Technical Service Bulletin: TSB260110

Improper Lubricating Oil Fill Practices Observed in Transit Applications

Figure 4, Cross-sectional view showing rear connecting rod interaction with the oil sump when the lubricating oil level exceeds specification.

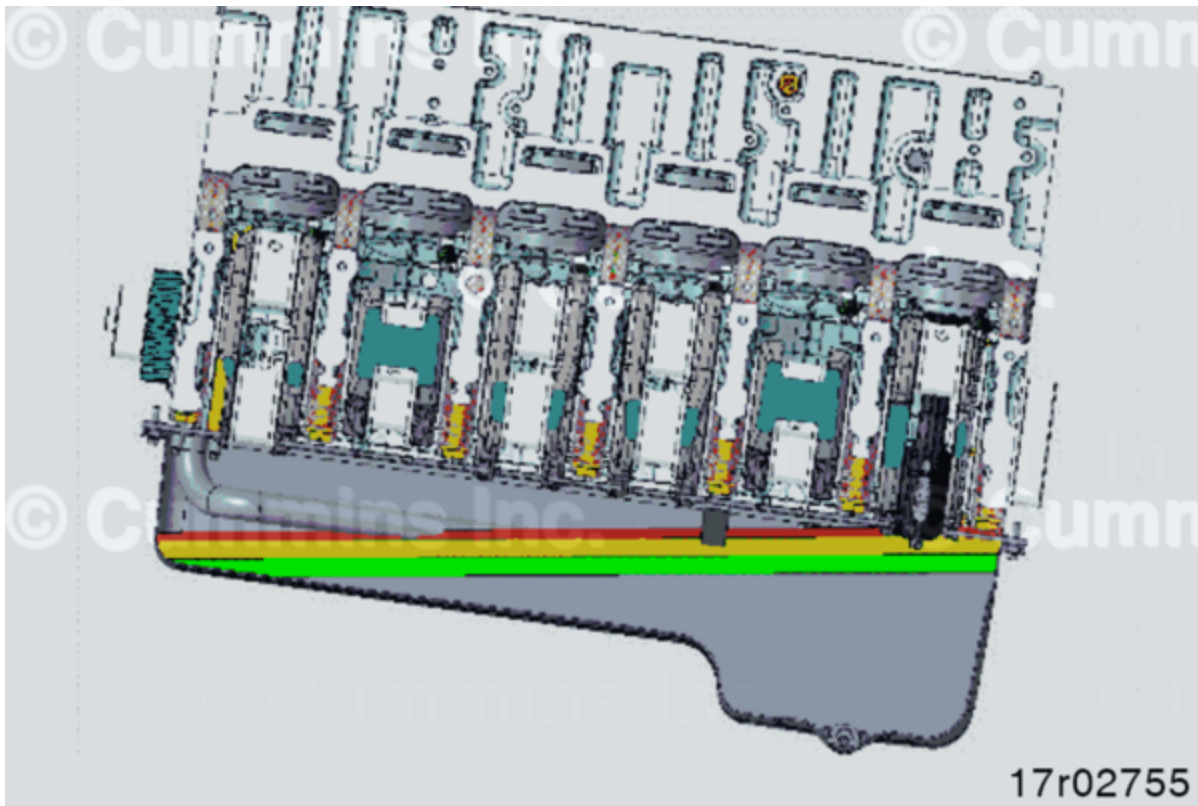
- Transit Application power angles increases the sensitivity of the engine to elevated oil levels, which can lead to the connecting rod dipping into the lubrication oil.

- This can create additional lubricating oil splash, leading to excess lubricating oil on the liners and potential impact on components.
- This can also lead to an increase in external lubricating oil leaks (lubricating oil pan and rear main seal).
